Staff Report

To: BOZAR
From: Jessie Earley, Town Planner III
Meeting Date: DRC, March 17, 2025
RE: 422 and 422 ½ Sopris Avenue, Final Review

PROJECT TITLE: Breuer Residence (422 Sopris Avenue)

SUMMARY: Consideration of the application of **John Andrew Breuer and Amy Padgett Breuer** to site a new single-family residence and accessory dwelling to be located at 422 and 422 ½ Sopris Avenue, Block 35, Lots 5-6 in the R1C zone. *Continued from the January 28, 2025 BOZAR meeting.*
(Ryan/Hadley)

PROPOSED TREE PLAN
1/8"=1'-0"

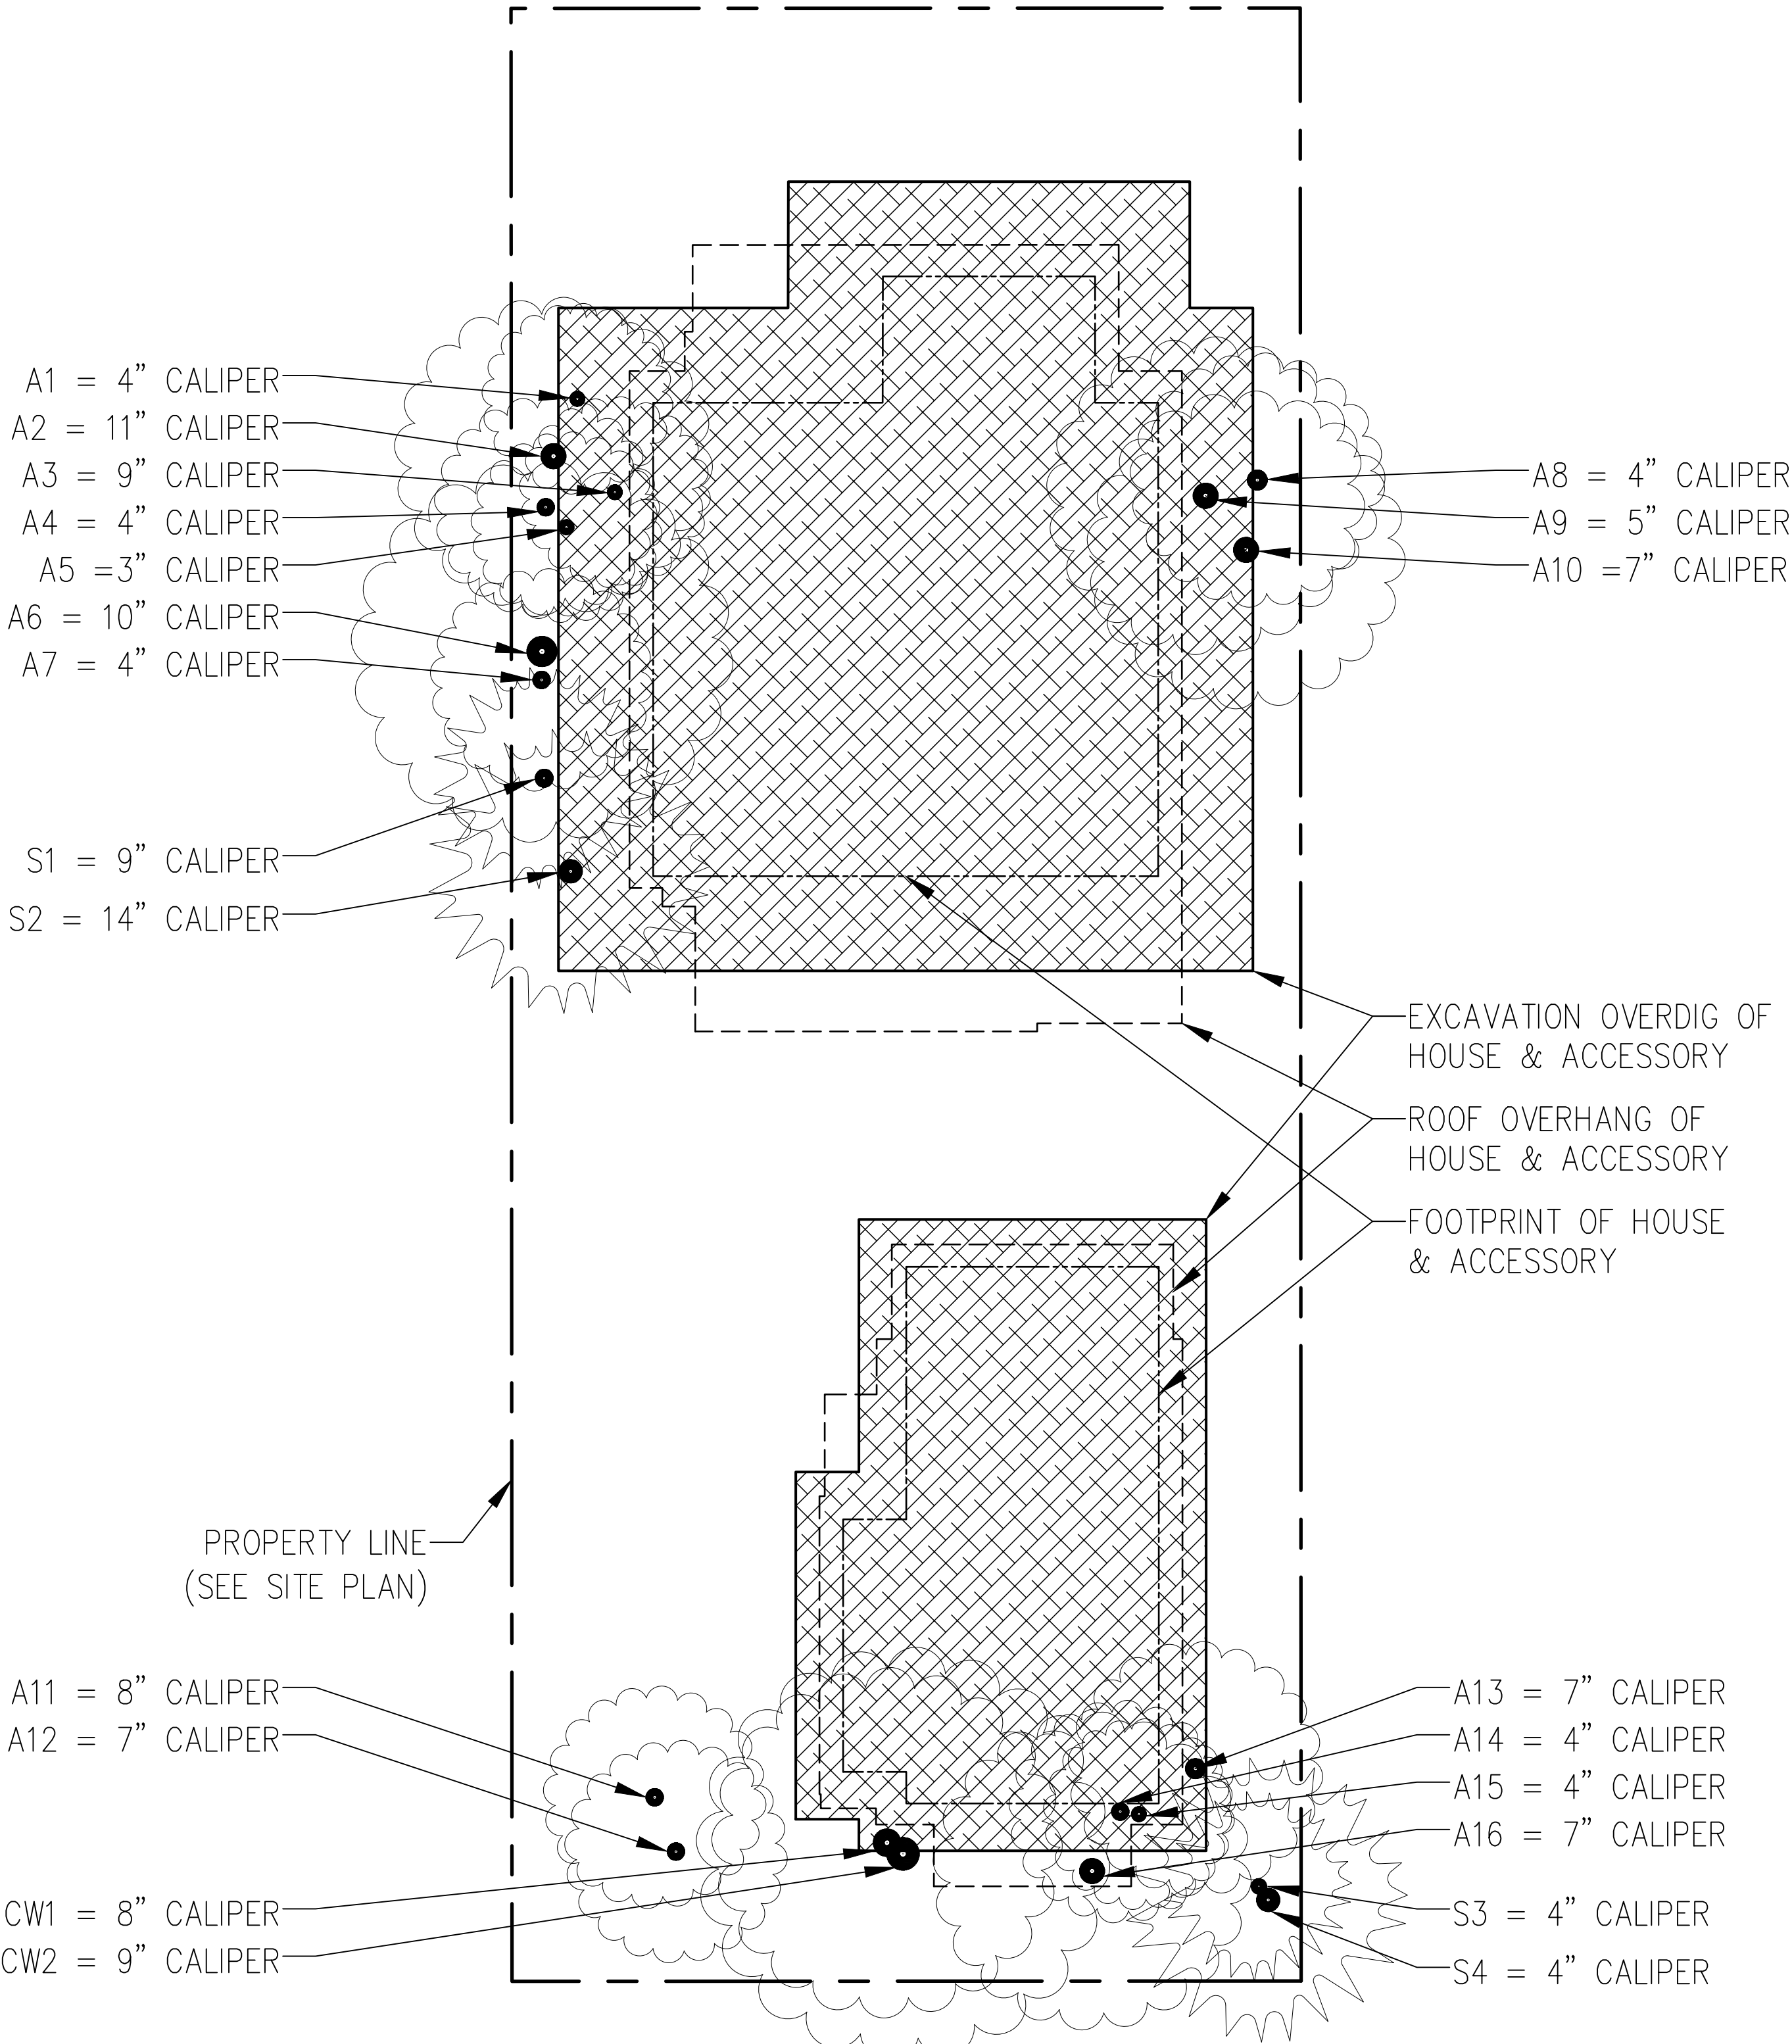
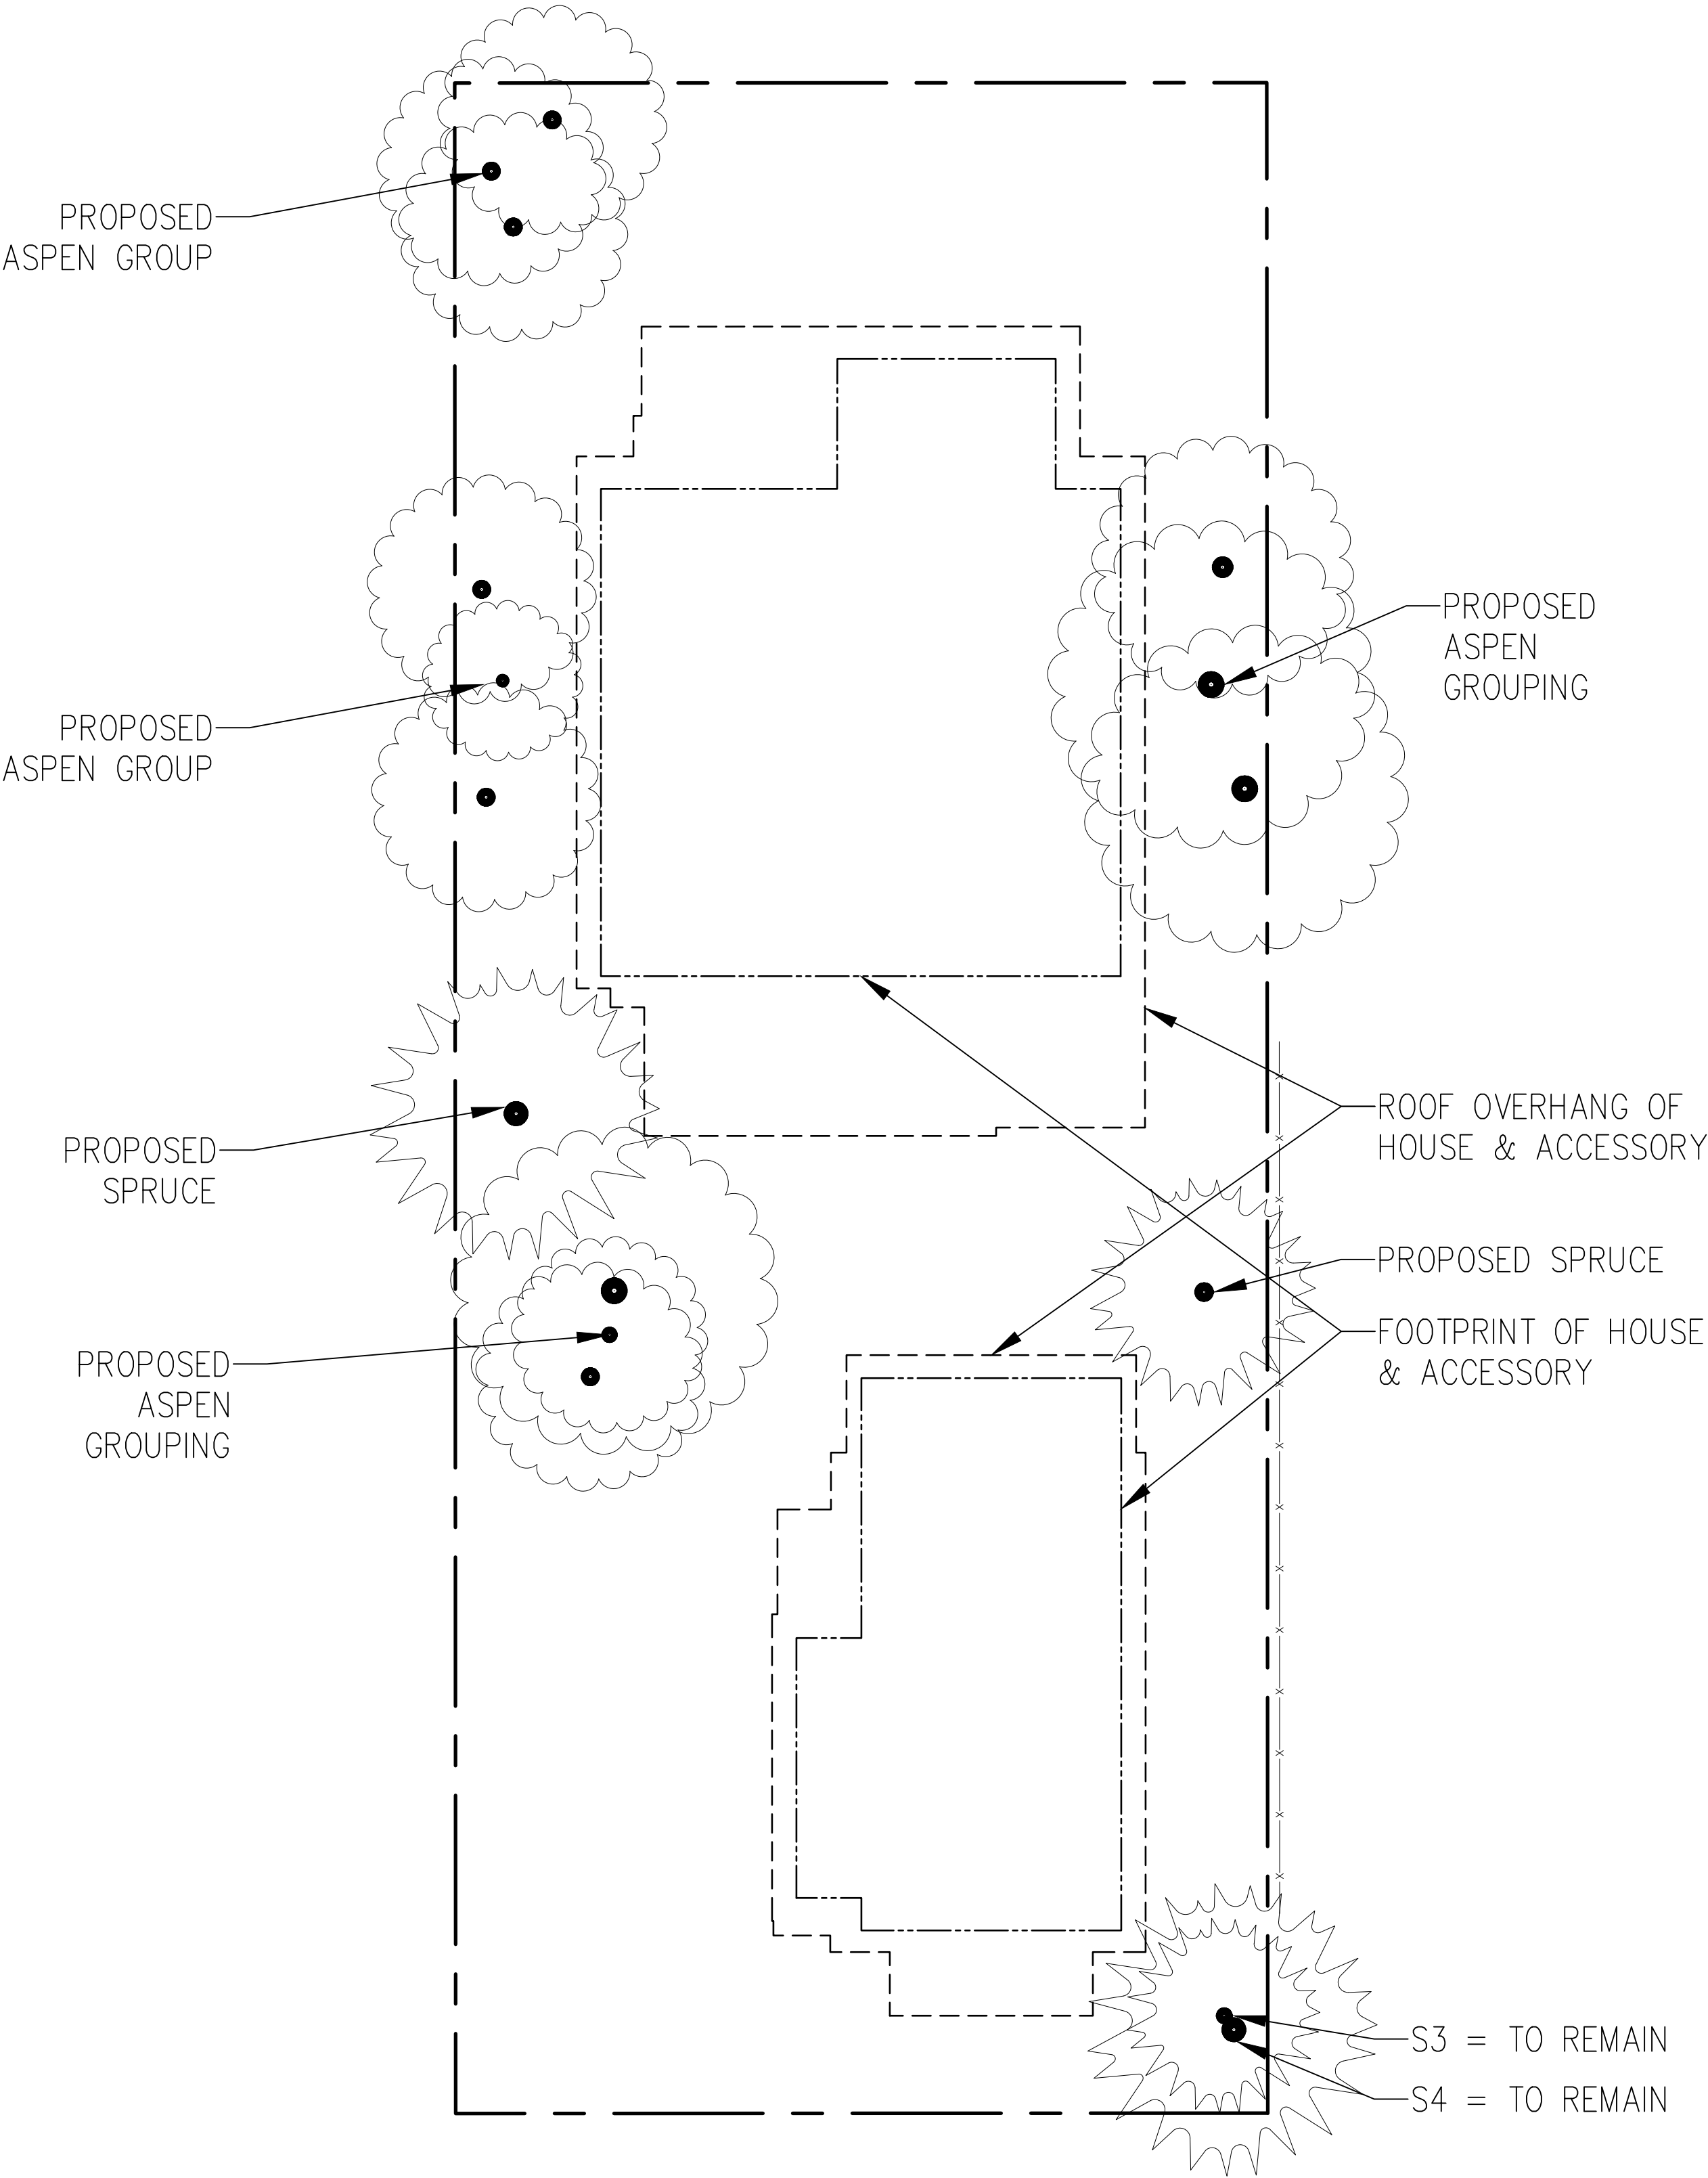
<p>than contemporary.</p> <p>Discussion is encouraged regarding the number of trees being proposed for removal, as part of the proposal. It is understood that trees impeding access on the south and development in the middle of the lot need to be removed. However, trees on the east and west sides are in question and if they all must be removed per GL 2.18. The applicant has provided a letter from an arborist clearly outlining the requirements of the site based upon the construction that is proposed. The applicant based upon this letter has provided a site plan showing the recommendations from the letter. Staff appreciates this information, as it better outlines what can be done for the health of the trees.</p> <p>Discussion is encouraged regarding the revised dormers, as proposed for the ADU.</p>	<p>removing the front gable. However they felt that this change made the building look more massive and therefore did not fit with mass/scale/form GL It was discussed that the front gable helped to break up the mass, but revisions were encouraged. The applicant has provided revised drawings.</p> <p>A consultation from an arborist was encouraged and the applicants are working on this piece.</p> <p>Members supported the two dormers better than the large dormer, as previously proposed. They have provided options with the rationale behind their choice for this element.</p> <p>3/17 DRC: Members asked if the cantilevered gable could continue to the ground and the applicant has provided revised drawings.</p> <p>Members appreciated the letter from the arborist, but asked for a site plan representing these recommendations and this has been provided.</p>

Trees: Hadley read members the report from Tomichi Trees, arborist. Members asked for a site plan showing the trees impacted by what was overviewed in the letter and also a healthy landscape plan, as overviewed within the letter. Hadley confirmed that they will provide this.

All trees within, and on the border, of the building envelope & excavation over-dig limits should be removed prior to construction. Rather than focusing on 100% canopy replacement; the final landscaping should focus on utilizing the correct species, and spacing, of replacement canopy.
